Agenda Item # 1

Application 2026-38-CA

Concept approval for the form, placement, and massing of a two-story brick single family home

STAFF ANALYSIS

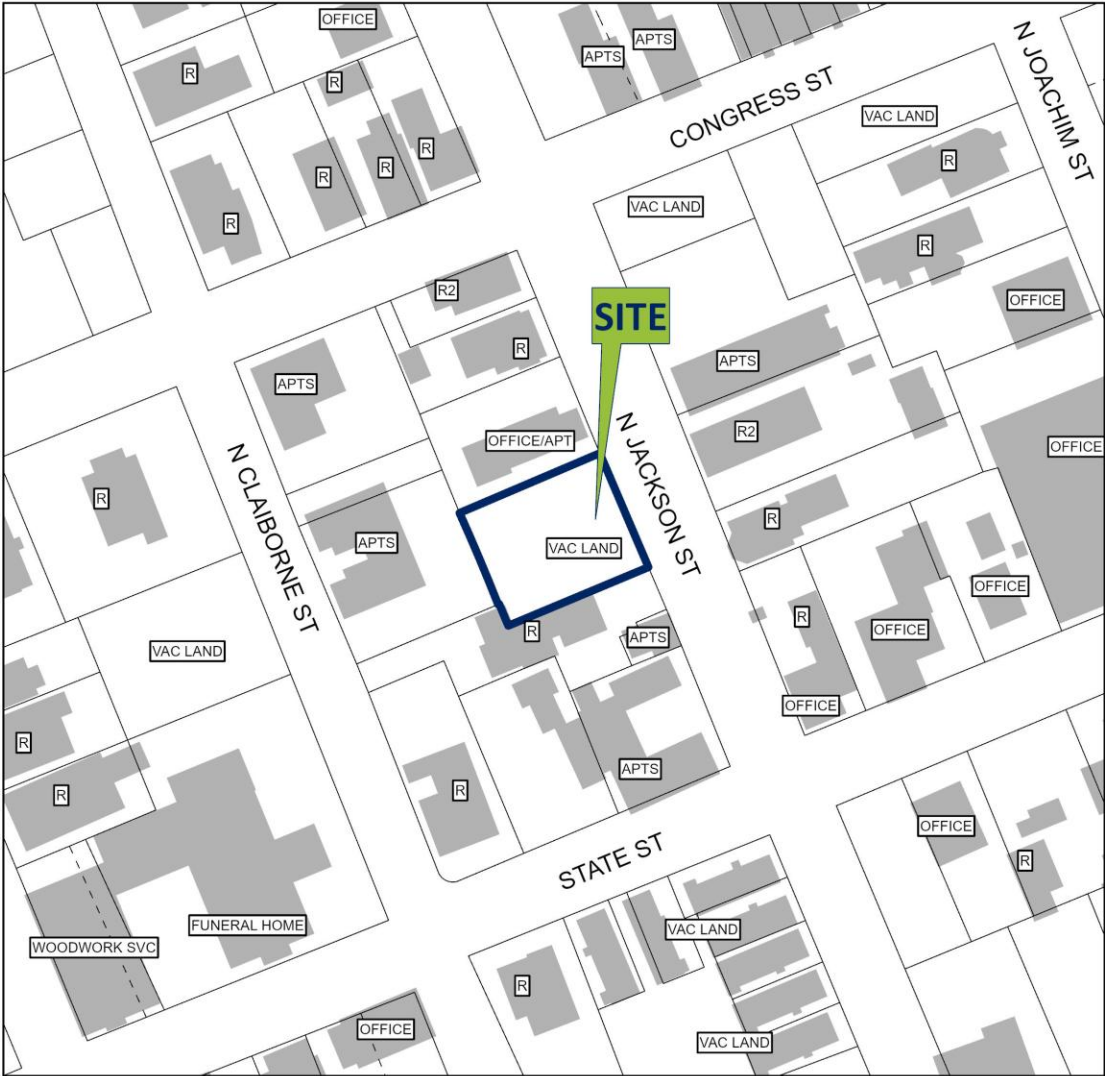
The sloped parapet wall and pediment caps of the proposed design is a treatment typically seen on the side elevations of parapeted townhouses in the district. The proposed design closely mimics the side elevation of 258 State Street, which presents a parapeted gable end to N. Jackson Street. While the use of this treatment on a façade is atypical of the district, it does reuse a traditional design feature in a way that clearly identifies the proposed dwelling as a modern construction. This complies with the *Guidelines'* directive that new construction should "differentiate itself from existing historic structures" while "drawing on the historic context" (p. 26).

The low-sloped hipped roof extending north beyond the parapet wall is incongruous with the overall design of the proposed structure. Staff were unable to find comparable combinations of parapeted and exposed hipped roofs on contributing properties within the district.

FRONT ELEVATION

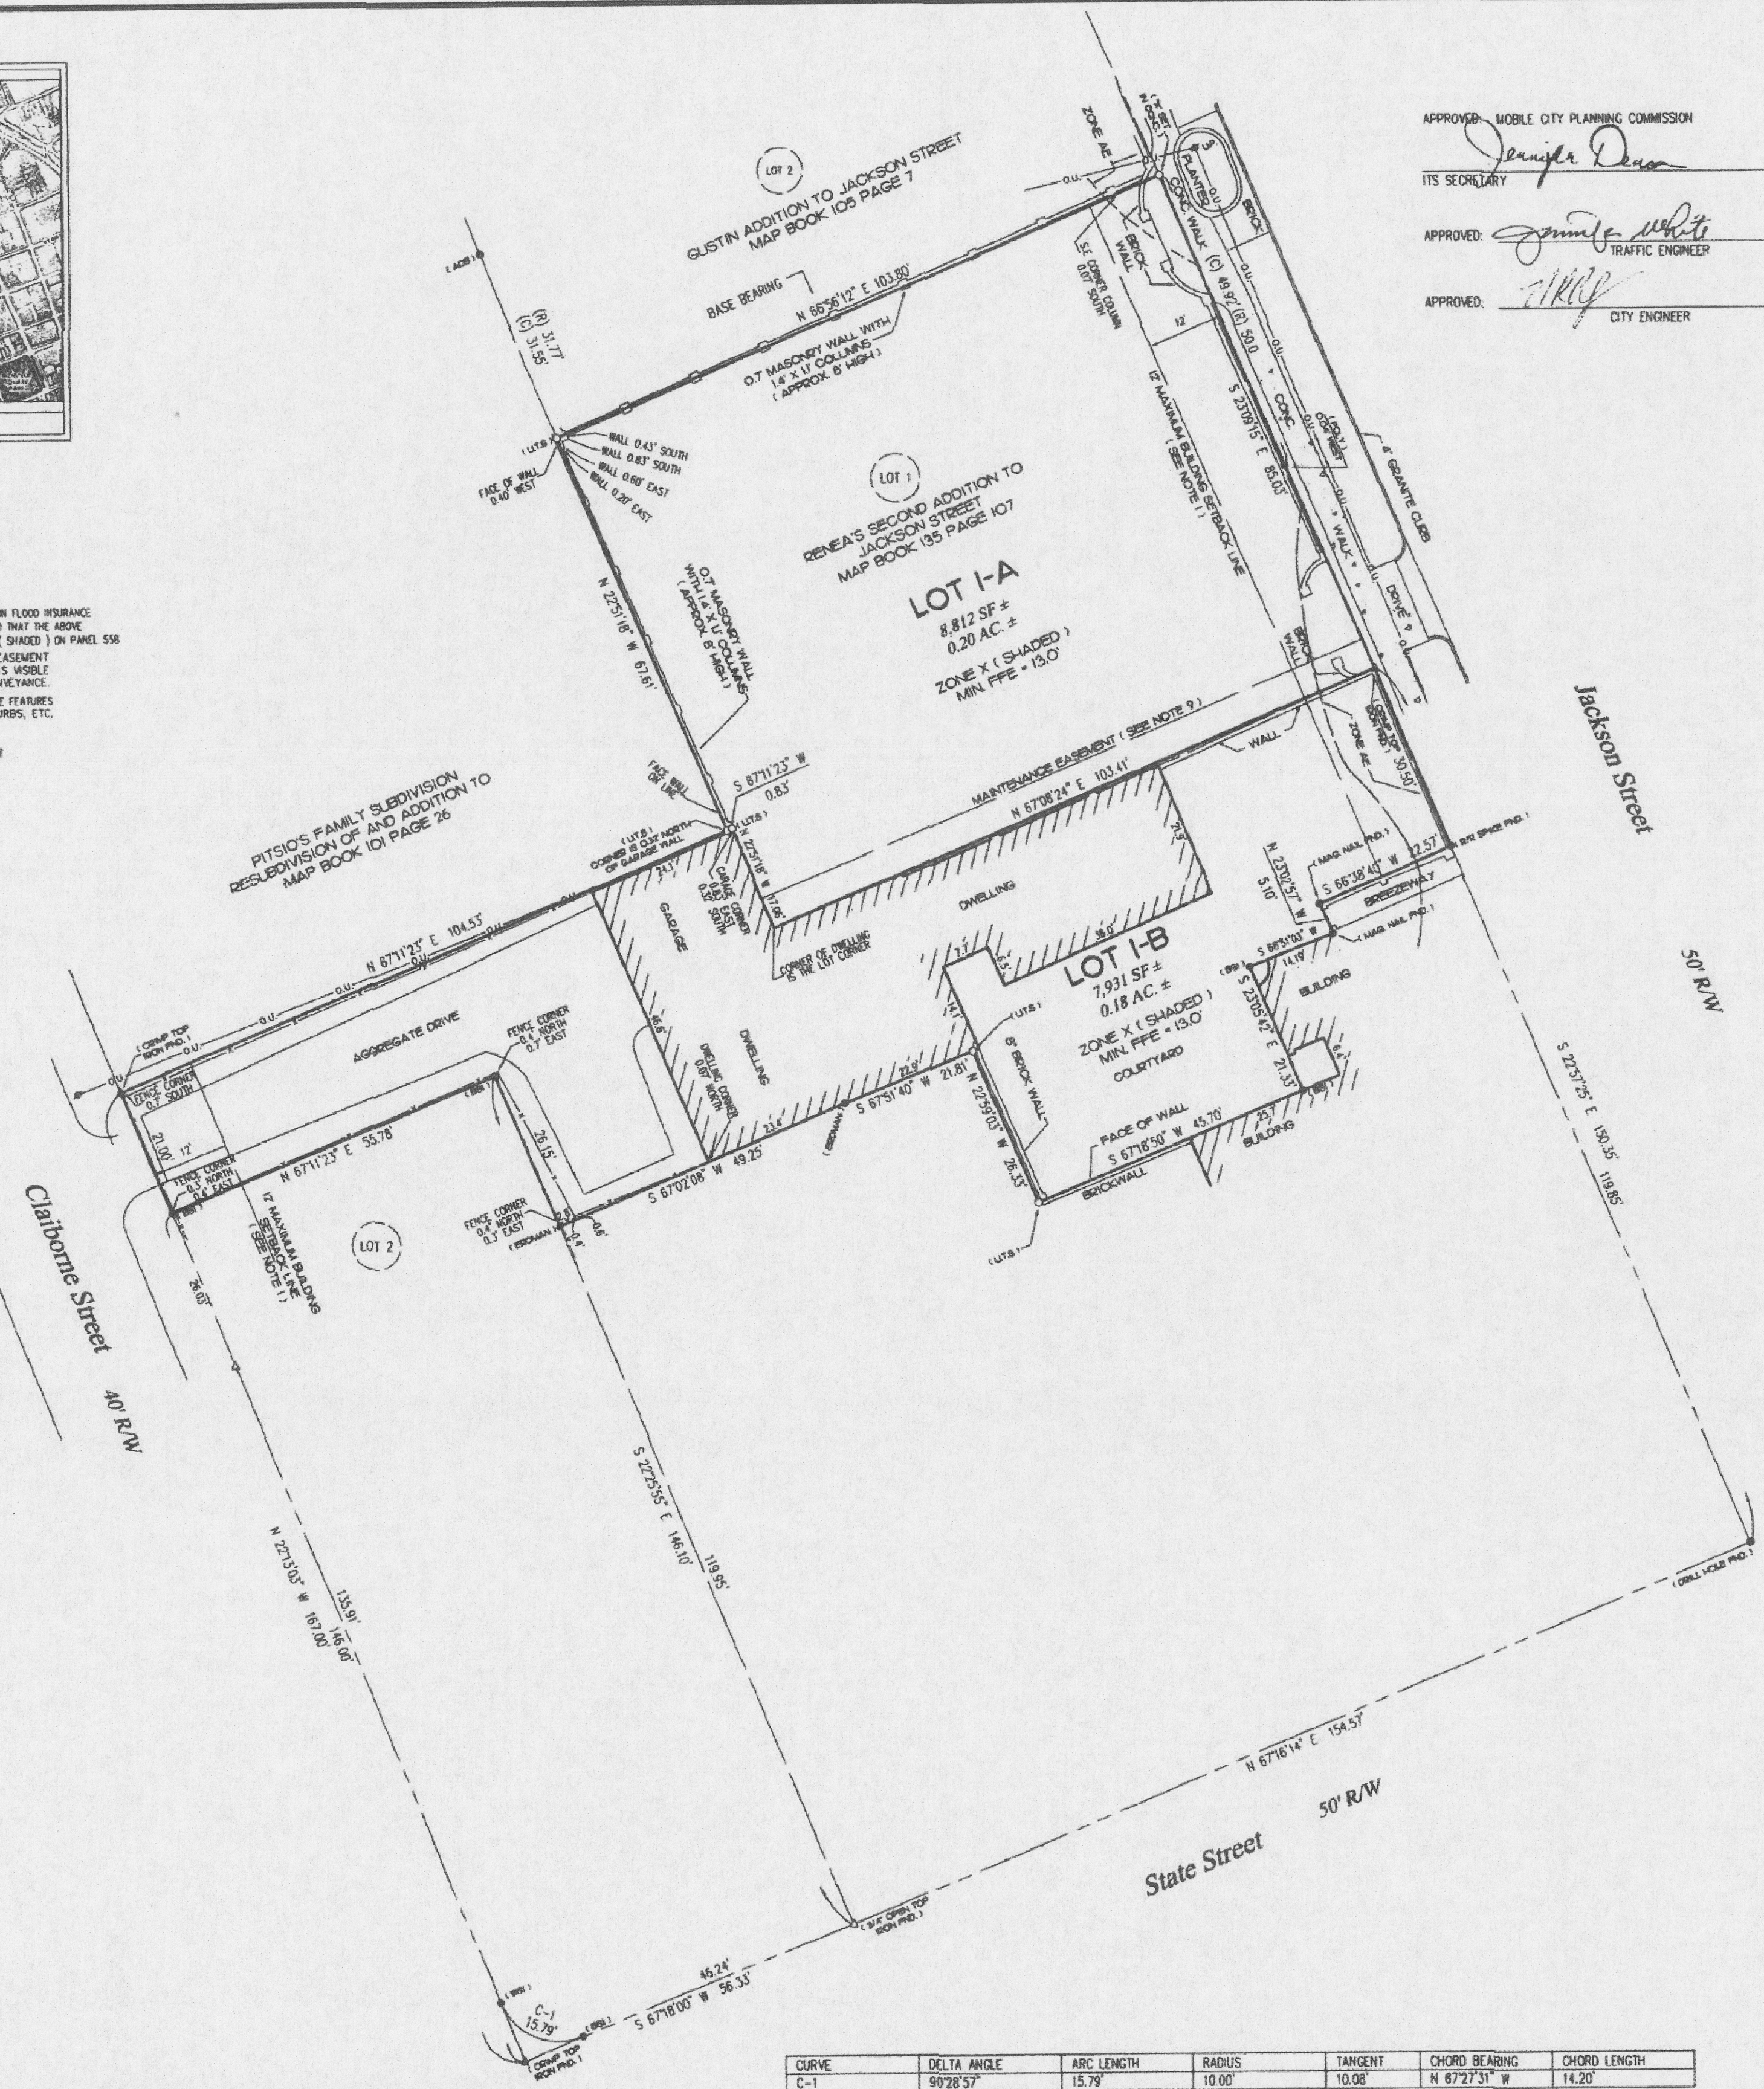
While the complex massing of the structure is not typical of most structures in DeTonti Square, including the properties along the same block of N. Jackson Street. However, there is at least one example of a contributing structure of comparable complex massing within the district. The most incompatible aspect of the massing proposed design is the fact that its long axis runs so prominently parallel to the street. All but one of the neighboring properties have a long axis that runs perpendicular to the street, and even this property has a considerably narrower façade than the proposed design.

261 N. Jackson is an outlier on the street. While its primary massing is also a simple rectangle, its long axis runs parallel to the street rather than perpendicular. While 261 N Jackson does have a long axis that runs parallel to the street, its façade is only three bays wide. In contrast, the subject property presents a façade that is approximately six bays wide. The visual impact of this discrepancy would be greatly

improved by recessing the south garage wing farther back from the principle front building plane. It is currently set back 5'-9" from the front building plane of the primary massing. Increasing this distance to 10' would create a massing more similar to that of 258 State Street, which features a prominent side wing that is approximately half the size of the main dwelling. It would also minimize the view of the two-bay garage from the street, in line with the *Guidelines'* directive that parking be minimally visible from the street (6.35, 10.7).
